## ADDENDUM NUMBER 2

**H27-6096-MJ**

**Outdoor Football Practice Felds Construction  
University of South Carolina**

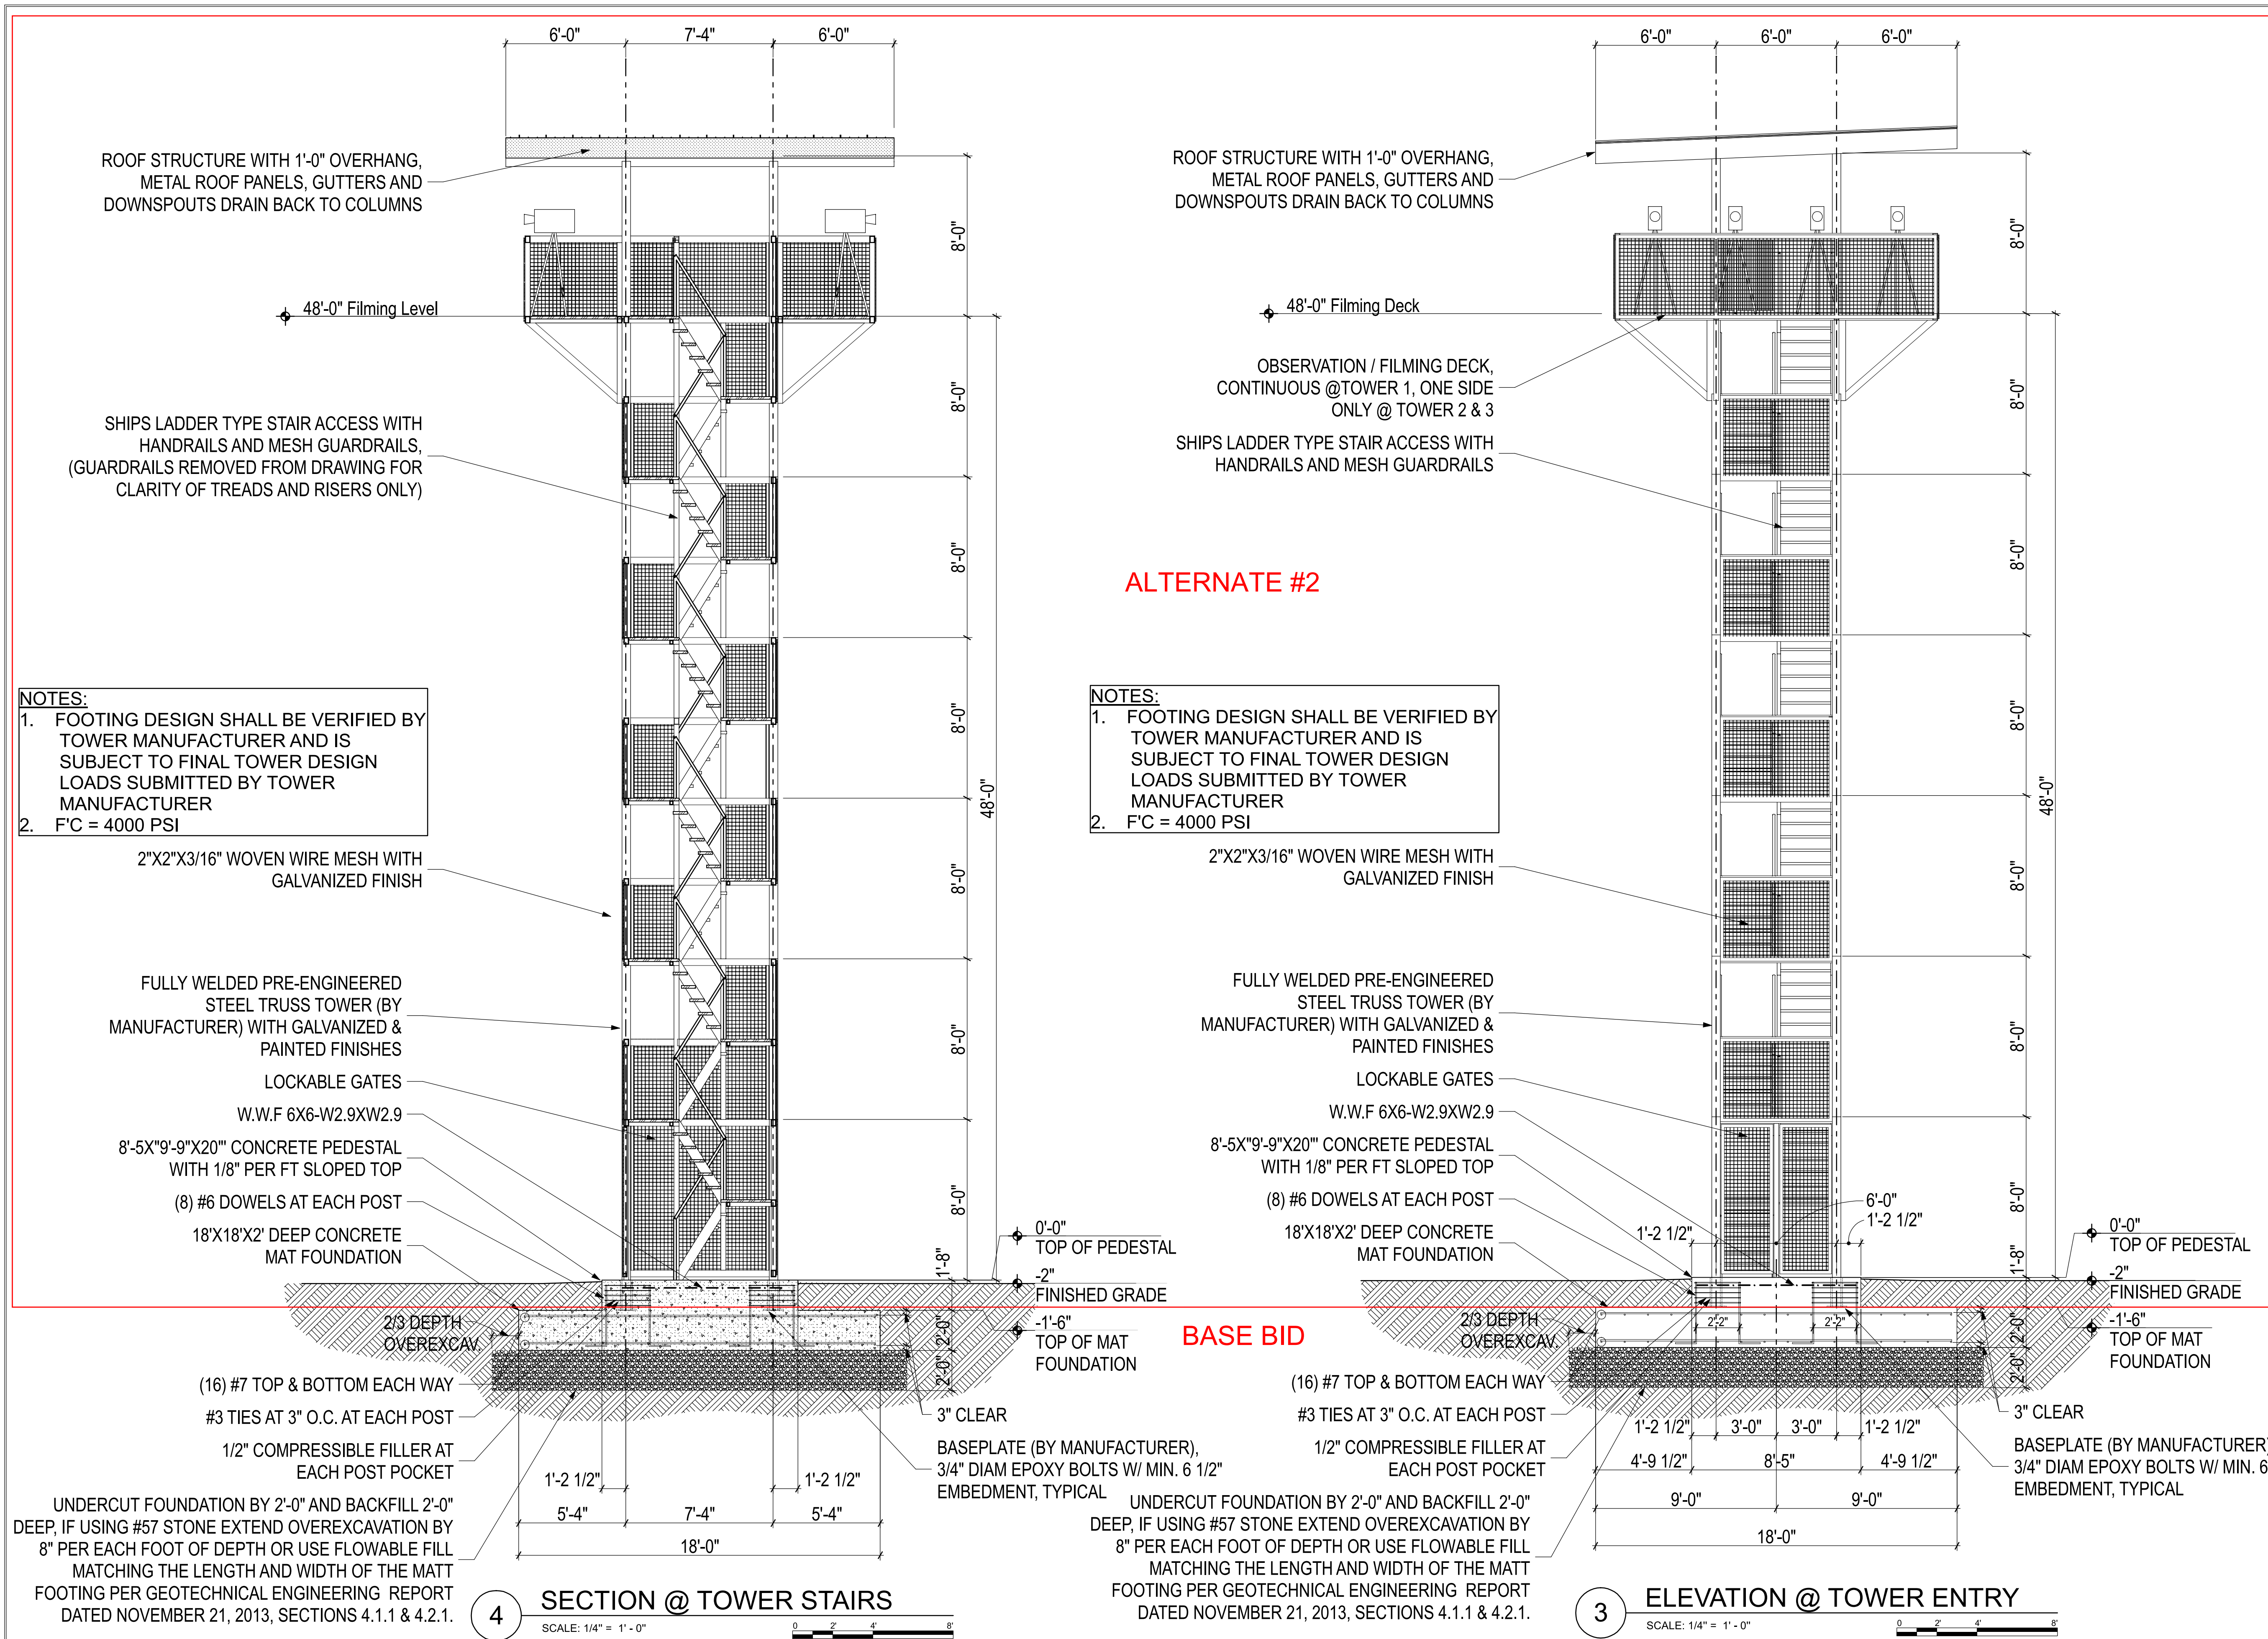
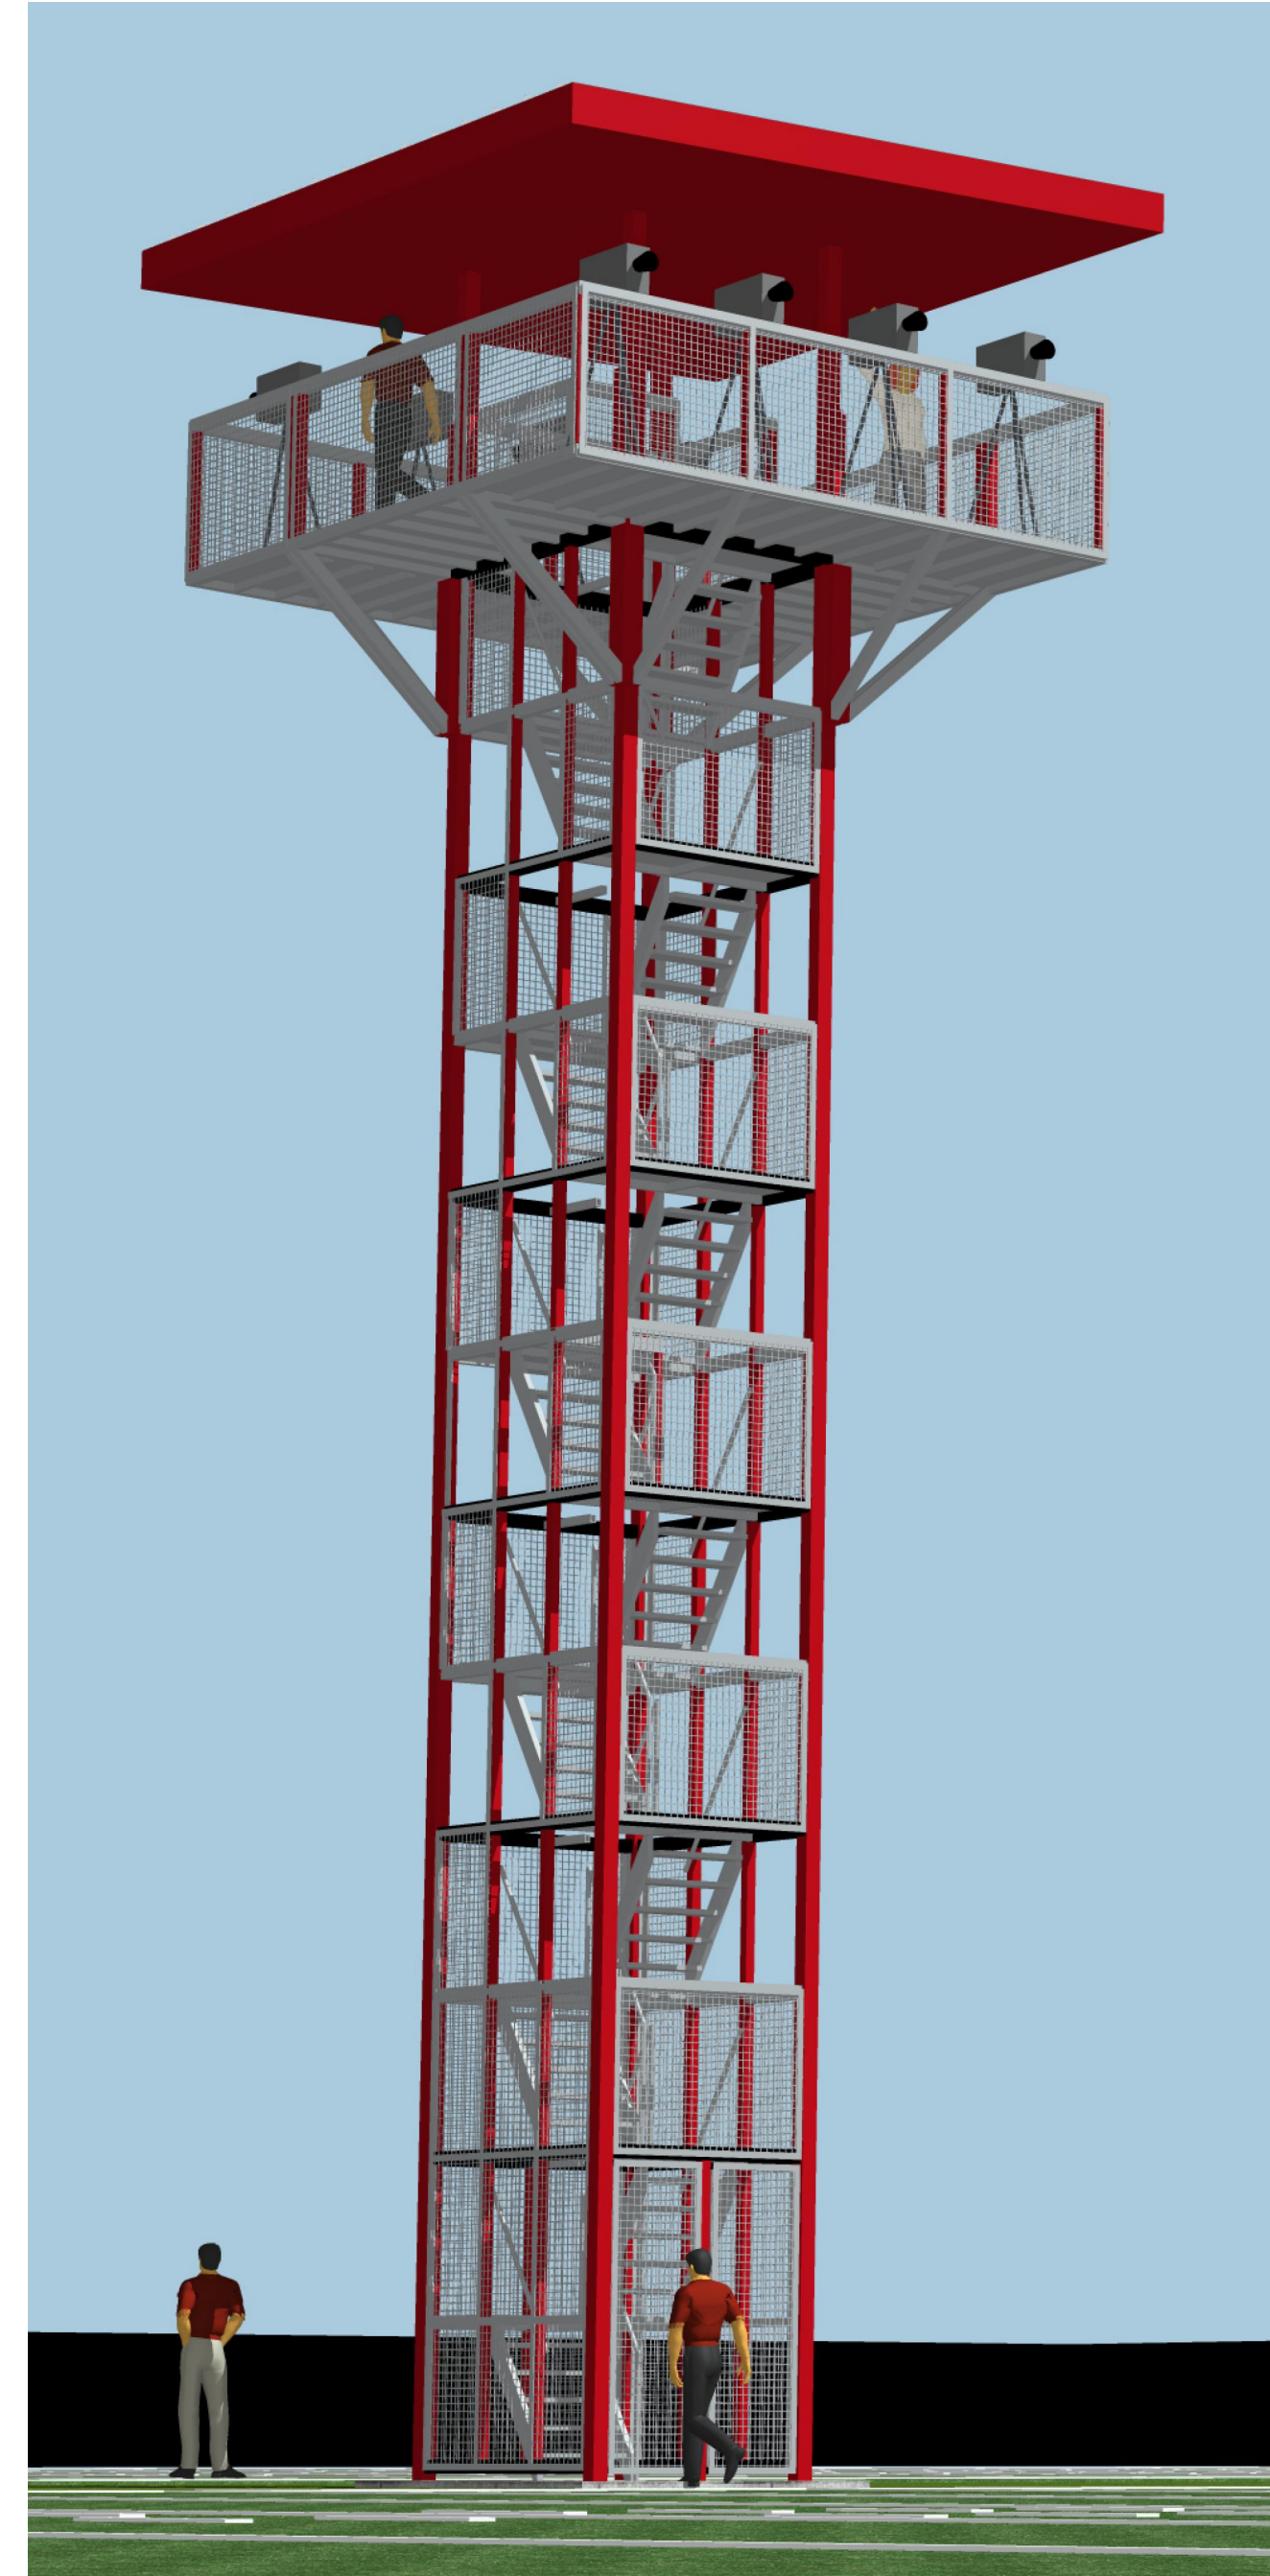
- e. Sheet A2.1 - Reissued to show filming tower base bid and alternate #2 scope of work.

NOTE:  
BASE BID SHALL BE INCLUSIVE OF MAT FOUNDATION SYSTEM AT ELEVATION -1'-6" AND BELOW. PROVIDE TOPSOIL BACKFILL OVER MAT FOUNDATIONS AND PREPARE TO RECEIVE OWNER PROVIDED SOD.  
ALTERNATE #2 SHALL BE INCLUSIVE OF PEDESTAL AND TOWER AT ELEVATION-1'-6" AND ABOVE. DOWELS AT POST LOCATIONS SHALL ONLY BE PROVIDED WITH ALTERNATE #2.
